Cascadia Center for Sustainable Design and Construction

Capitol Hill Design Review Board Recommendation Packet

November 17, 2010

DPD Project # 3011010

Fifteenth Avenue Entry

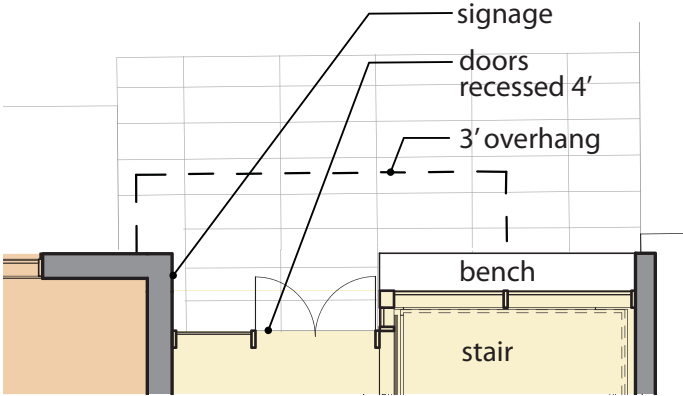
The Board encouraged the location of the entry area on 15th Avenue to maximize the spatial and visual relationship with McGilvra Place. The Board was less enthusiastic about and questioned the proposed secondary entrance off Madison Street. This secondary entry would require a dimensional departure to have the stair overhang the sidewalk above the first floor. These concerns were alleviated by the explanation that the need to discourage energy usage of the elevator favored a grand entry stair location at the highest point of the site off Madison Street. The stair design would also include interactive graphics or other informational displays regarding energy usage at the building.

Fifteenth Avenue Entry: The 15th Avenue entrance will primarily be used by visitors. This entrance opens up to McGilvra Place across the street, and the paving is designed to create a continuous relationship between the entry and sidewalk. Because the 15th Avenue entry is recessed, an awning or canopy over the sidewalk is not necessary. Instead, a natural wood soffit will continue from the exterior to the interior and will add color and warmth to the entry. Building name signage will be located on the south entry wall and may include an accent color.

- Highly transparent building facade and floor-to-ceiling storefront window system will reveal uses inside the building and activate the pedestrian realm.
- Double-height building entry is set back to maximize daylight within interior spaces and provide weather-protection for those entering and exiting the building.
- An interior vestibule will moderate heat exchange and potential temperature variation between interior and exterior spaces.
- The entry is aligned with exterior seating, bicycle parking, sidewalk plantings and a small 'plaza' that extends across the parking strip for safe pedestrian drop-off and pick-up.
- Building name signage will be located on an entry wall and may illuminated by an accent color.

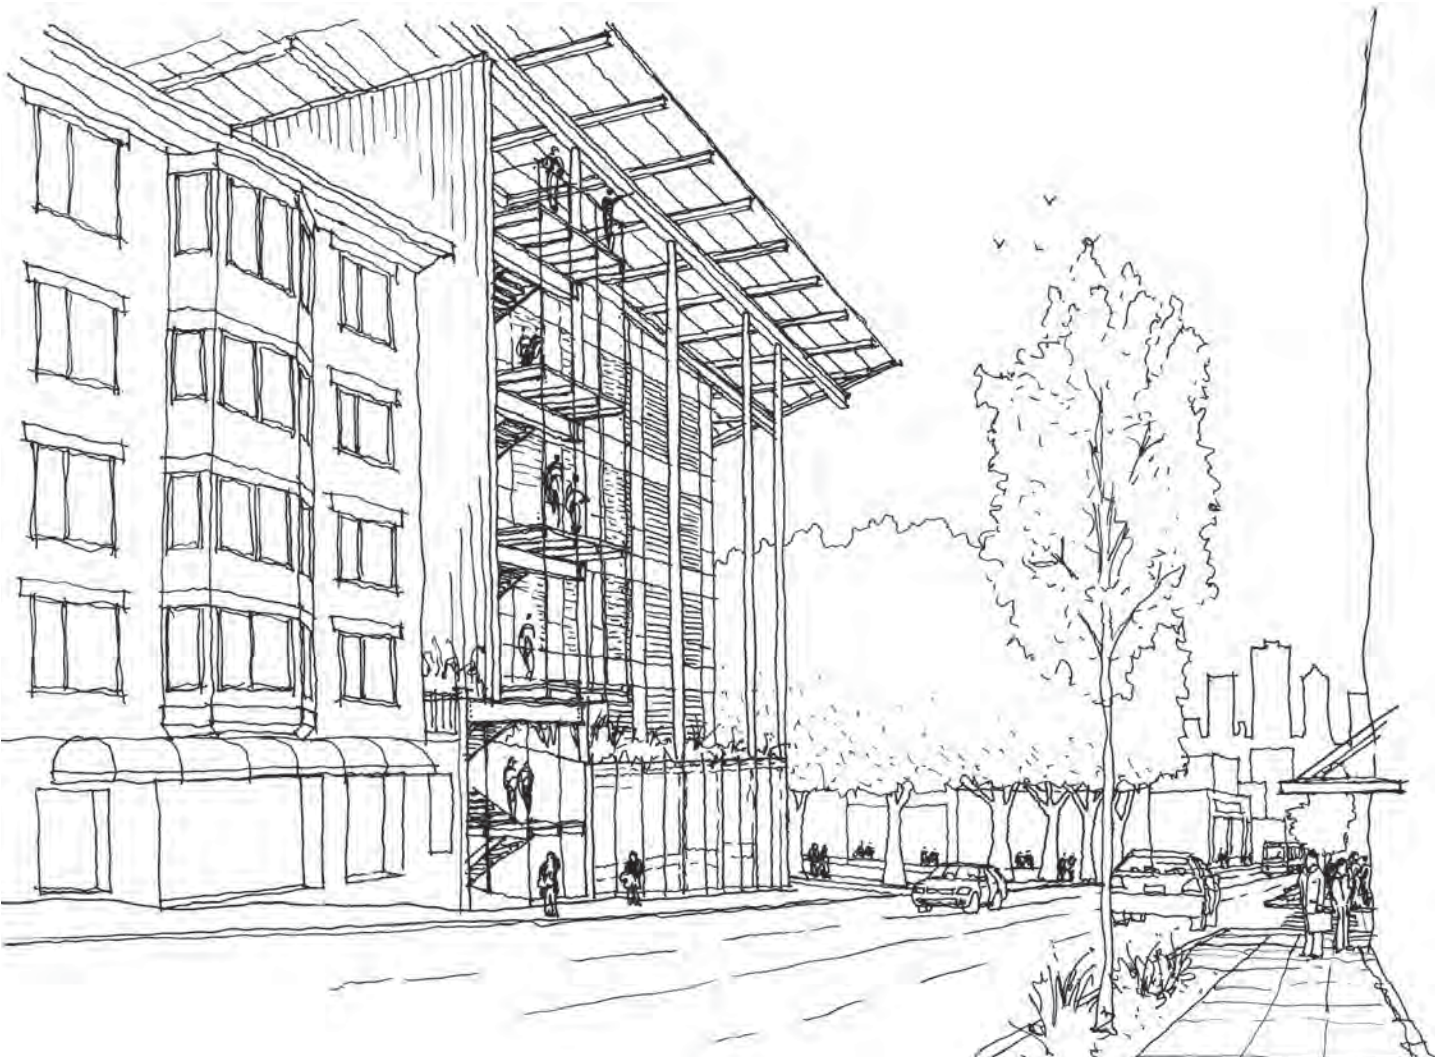
(From E-3) The Board is concerned about the relationship to the residential building to the east and would like to see plans to create an attractive buffer between the two structures. This buffer should consider views to and from the abutting buildings to maintain privacy, daylight, landscaping, form and materials. See also, B-1, C-4, D-2, D-7.

Building Massing: The new building is designed to be under the allowable FAR by 50 sf. The mass of the new building will respect adjacent development patterns along Madison Street, which is becoming increasingly built out along property lines. The ground floor massing (21’ tall) will be built out to Madison Street. While zoning does not require any setbacks, the upper four floors step back approximately 15’ from both the Madison Street and the alley sides of the building. Overall, the building will not block public right-of-way views to downtown and surrounding mountains.

While the Board preferred the upper floor massing to be located along the Madison frontage, shifting the mass of the building any farther to Madison would require supporting a PV overhang almost 40 feet deep on the south side of the building. However, both the first and second level massing and the columns supporting the PV array, as well as the main stair will be built out to property lines to establish a street edge along Madison Street.

By distributing the open space on both the southeast and northwest sides of the building, a south-facing terrace and a northwest facing green roof for greywater treatment are created. (See E-2 for more information on the greenroof greywater treatment.) The terrace, which is across the alley from an L-3 residential zone, will reduce massing impact on the neighboring low rise zone.

Design Guidelines: Massing, cont'd

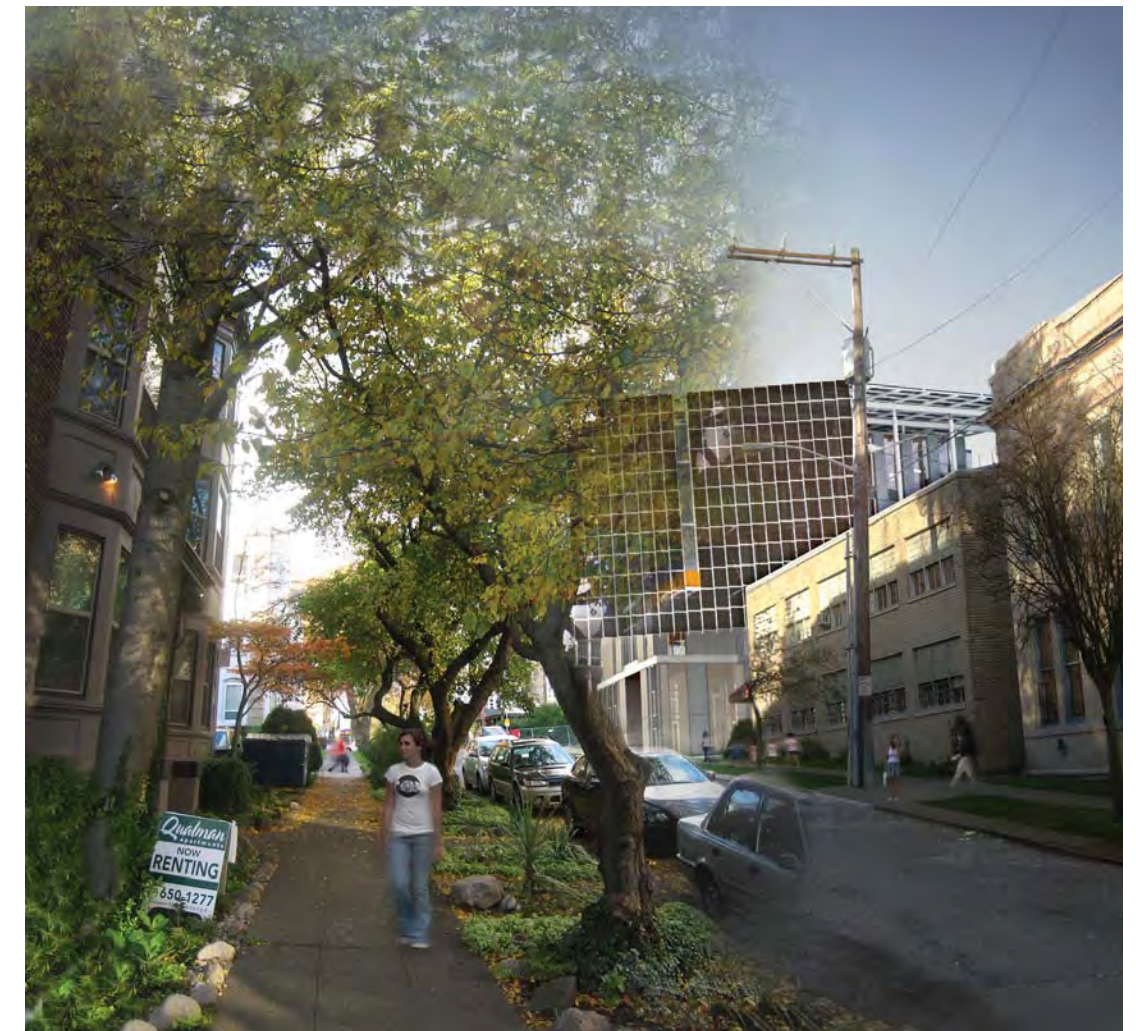
(From C-4) The Board strongly agreed that much more detail regarding the vertical PV array is necessary. What this array looks like to neighbors and pedestrians is crucial. The design of this array should be mindful of glare and blank wall effects. The Board noted a concern for the portion of the array that projects over the sidewalk and agreed that this feature should feel light and elegant, not heavy and oppressive. The Board was also concerned that the proposed deck projection at the southwest corner was a dominating feature over the public space and did not see either a design or Living Building Challenge imperative for such a projection. The Board wants to see further exploration of the PV arrays that will result in a less dominating element.

- Rooftop PV Array
- Steel PV Support Structure, Painted White
- Open Slot Added for Light & Views, Breaks-Up Mass
- Semi-Transparent PV Panels
- Sunroom
- Level 3 Terrace
- Garage Entry

vertical PV array has an open frame and photovoltaic panels that allow filtered light to enter below. An open, vertical slot has also been added to the center of the array to break up the massing, introduce direct sunlight, and provide greater views through the array. The bottom of the array is 26 feet above the sidewalk. This array does not interfere with the pedestrian experience of the building in any way. It is also anticipated that the array will get smaller over time as photovoltaic technology produces more efficient panels.

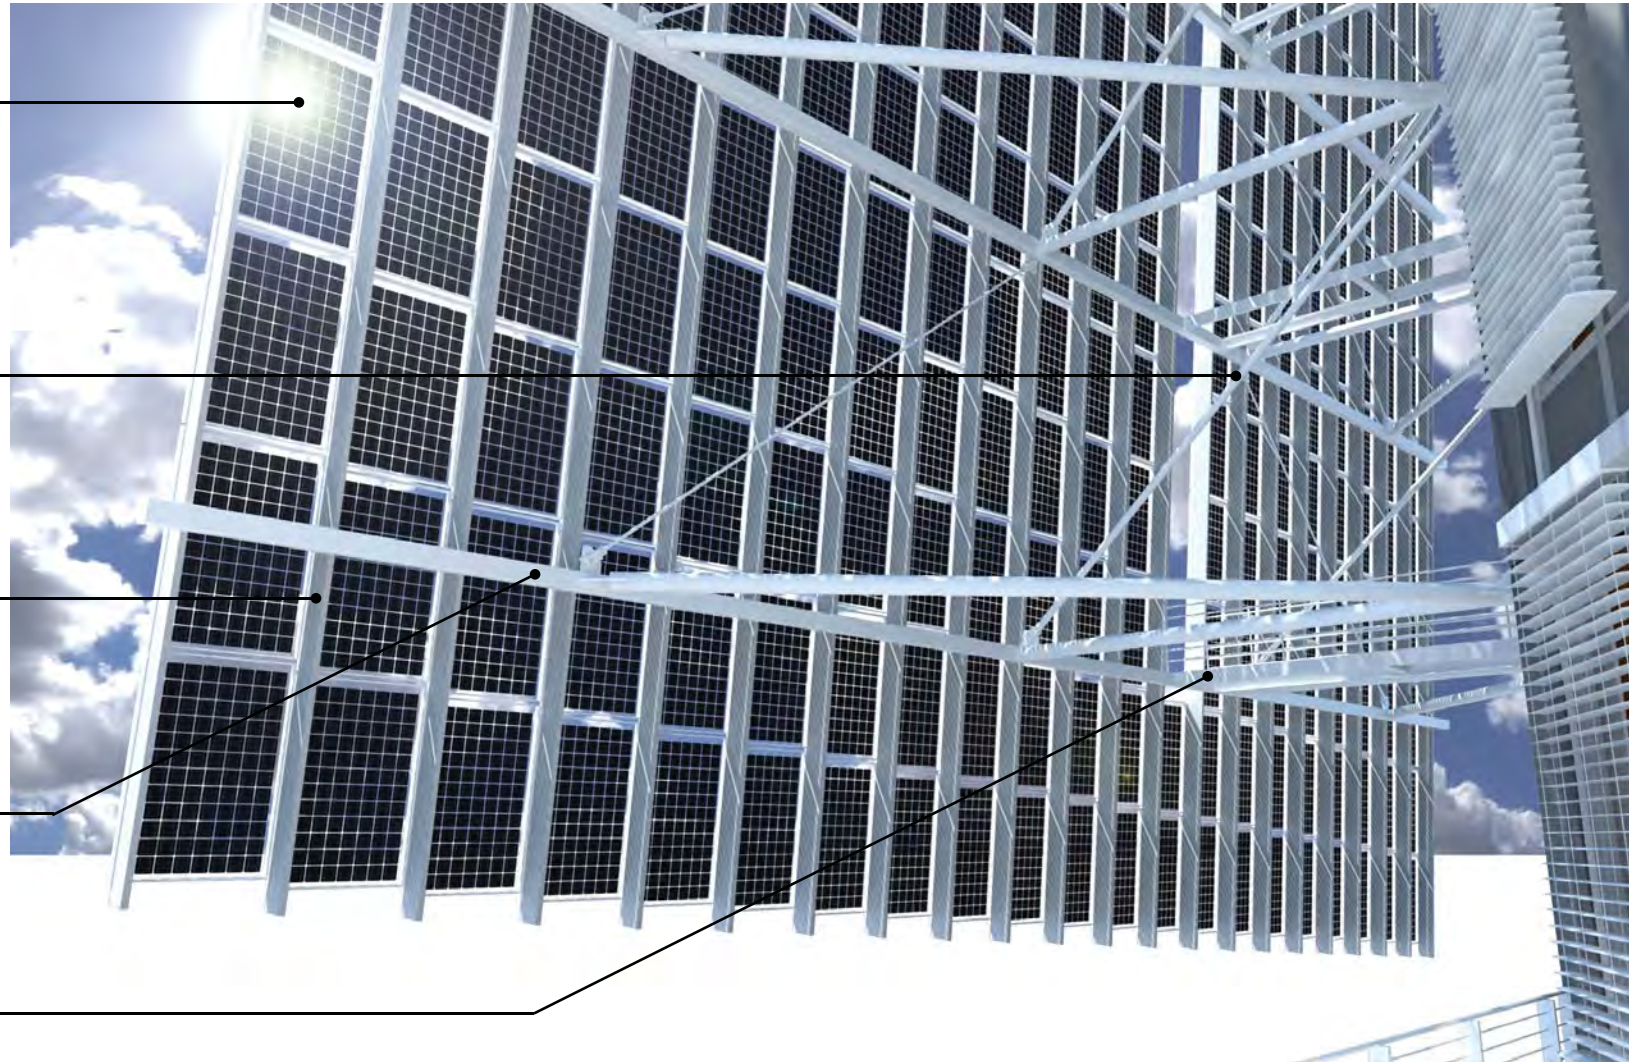
(From C-4) The Board strongly agreed that much more detail regarding the vertical PV array is necessary. What this array looks like to neighbors and pedestrians is crucial. The design of this array should be mindful of glare and blank wall effects. The Board noted a concern for the portion of the array that projects over the sidewalk and agreed that this feature should feel light and elegant, not heavy and oppressive. The Board was also concerned that the proposed deck projection at the southwest corner was a dominating feature over the public space and did not see either a design or Living Building Challenge imperative for such a projection. The Board wants to see further exploration of the PV arrays that will result in a less dominating element.

BI-FACIAL PHOTOVOLTAIC
PANELS SEMI-TRANSPARENT

STEEL CROSS BRACES
(PAINTED WHITE)

MAINTENANCE WALK (PAINTED WHITE)

The array is lightweight and airy. The support structure is composed of stacked, bypassing steel members to create layers that lighten toward the edges. The steel support structure of the vertical south array employs tensile rods that take both gravity and uplift loads to further reduce the amount of material and overall weight of the structure. To accentuate the canopy's lightness, the steel will be painted white.

The steel structure supports a layer of extruded aluminum rails. These extrusions are designed to accommodate wire bundles within an open structural profile. This will keep the array orderly and well composed when viewed from below. The aluminum rail system will be sculpted in profile to facilitate bifacial solar energy collection.

Lighting Site Plan

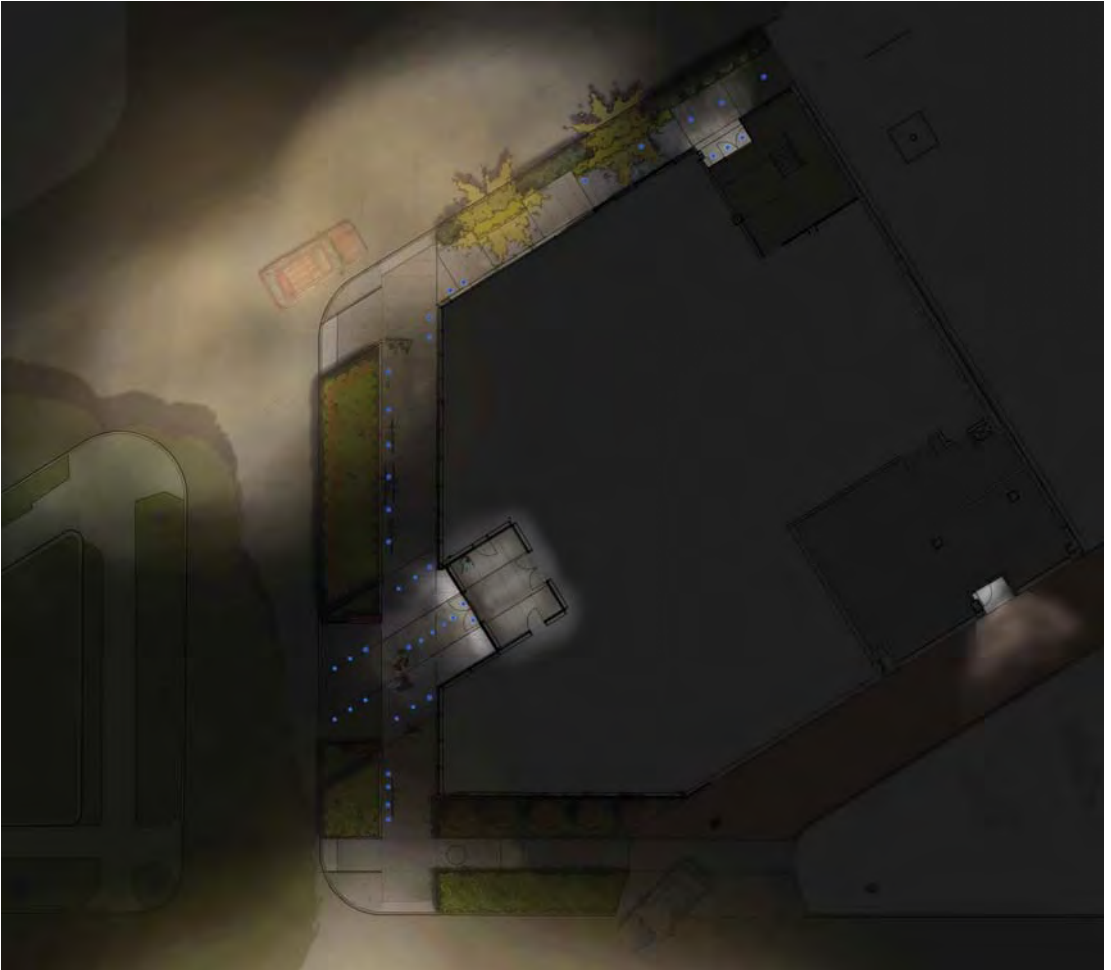
Mechanical Expression: The Board indicated it was interested in how the mechanical systems of the building would contribute to the educational experience of the living building. Primarily, several photovoltaic technologies will be on display, including roof panels, bifacial panels, and the possibility of building integrated photovoltaics (BIPV) is being explored. Within the publicly accessible ground floor, windows into the mechanical and electrical rooms will display mechanical, plumbing and electrical systems to passers-by interested in fully exploring the building. Finally, a greywater treatment bioswale will be on display in the planting strip on 15th Avenue. To meet Living Building requirements, interpretive displays will highlight these elements for the public.

To achieve net zero energy requirements, most equipment and lighting will be turned off at night—roughly between 7:00 pm and 7:00 am. However, during the dark months of winter or during late-night meetings on the ground floor, the interior will be illuminated and provide visual interest to the street outside. In addition, emergency lighting at the entries will be on when it is dark, and there will be a minimal amount of exterior lighting along the sidewalks. This will illuminate the pedestrian realm without impacting adjacent properties.

- Lighting will be provided from overhead luminaires at both entries.
- Blue LED sidewalk luminaires are one of the most energy efficient lighting sources available, using 40% less power than warmer colors because the human eye is more sensitive to the blue spectrum.
- Street lights provide adequate illumination of the public realm.
- No lighting from this project will spill onto other properties.

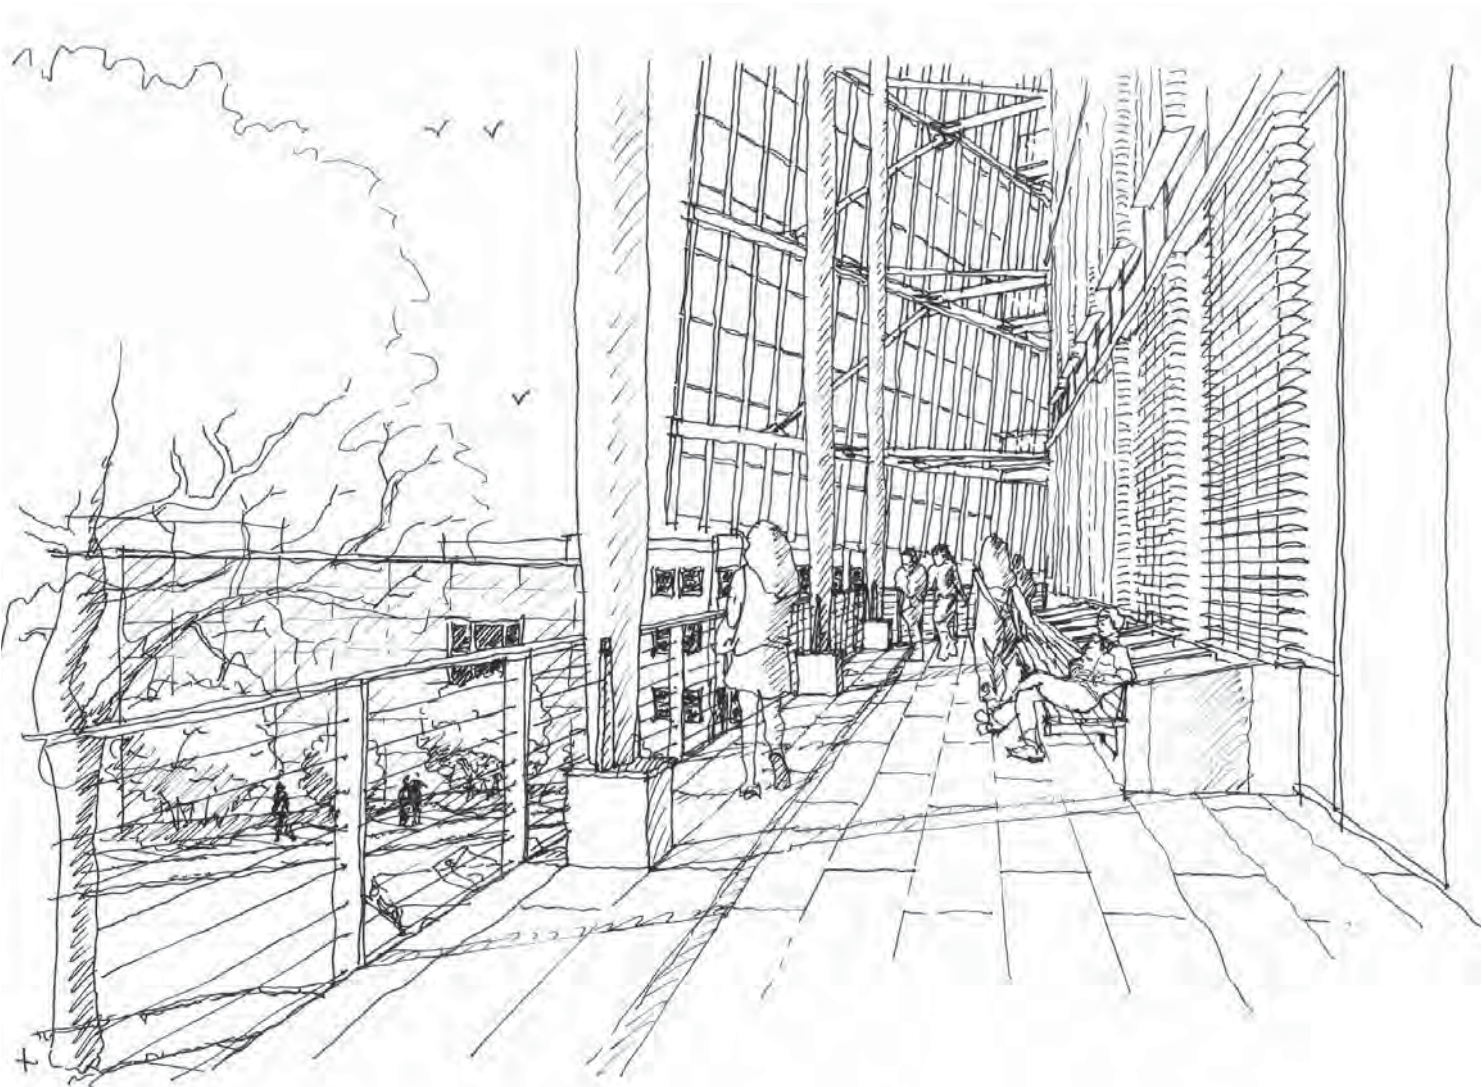
(From D-1) The Board expressed concern that the pedestrian environment appeared too oppressive and need to be further integrated into the ground floor of the building, and include wider sidewalks (greater than ten feet) and planting strips.

Alley: The design of the lower floors will take advantage of the openness of the alley at its diagonal relationship to the site. The entrance to the garage will be located on the northeast property boundary to maximize glazing on the remainder of the facade that faces the brick paved alley. Utility work will be necessary in this alley, but an effort will be made to replace the existing brick paving if allowed by SDOT. Landscaping will be added in the planting strip where the alley meets Pike Street.

Terrace: On the south side of the building where sunny days can be enjoyed, a third floor terrace for office occupants will open to the quiet residential neighborhood to the south. This will be landscaped with potted herbs or indigenous plants.

Maintenance Access: As a response to the Board's comments, the southwest decks have been eliminated. In its place, a single, narrow maintenance walk is proposed.
